Model DA20-C1

# **OPTIONAL SERVICE BULLETIN NO. DAC1-27-05 REV. 0**

Replacement of the flap actuator and installation of the flap resistor assembly.

ATA code: 27-50

Figure 2. Flap actuator and flap resistor assembly installation

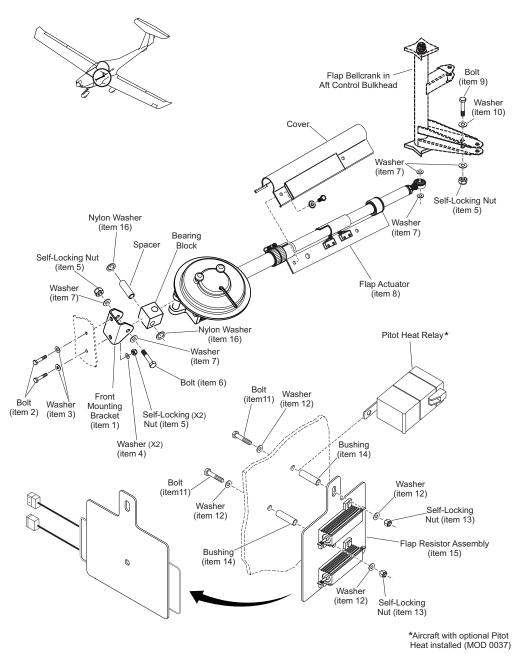
- 3. Remove the bearing block from the existing flap actuator. Refer to Figure 2.
- 4. Remove the bolts, washers and self-locking nuts which attach the front mounting bracket. Refer to Figure 2.

- 7. Install the bolts (item 2), washers (items 3 and 4), and self-locking nuts (item 5) which attach the new front mounting bracket (item 1) to the aircraft. Refer to Figure 2.

- 8. Apply Aero Shell Grease 22 to the spacer and the bearing block. Refer to Figure 2.
- 9. Install the bearing block to the new flap actuator (item 8). Refer to Figure 2.

- 10. Put the spacer and the nylon washers (item 16) in the installation position. Refer to Figure 2.
- 11. Install the bolt (item 6), washers (item 7), and the self-locking nut (item 5) which attach the new flap actuator (item 8) to the to the new front mounting bracket (item 1). Refer to Figure 2.

- 14. Install the bolts (item 11), washers (item 12), bushings (item 14) and self-locking nuts (item 13) which attach the flap resistor assembly (item 15), and the two relays (three relays if MOD 0037 Pitot Heat installed). Refer to Figures 1 and 2.
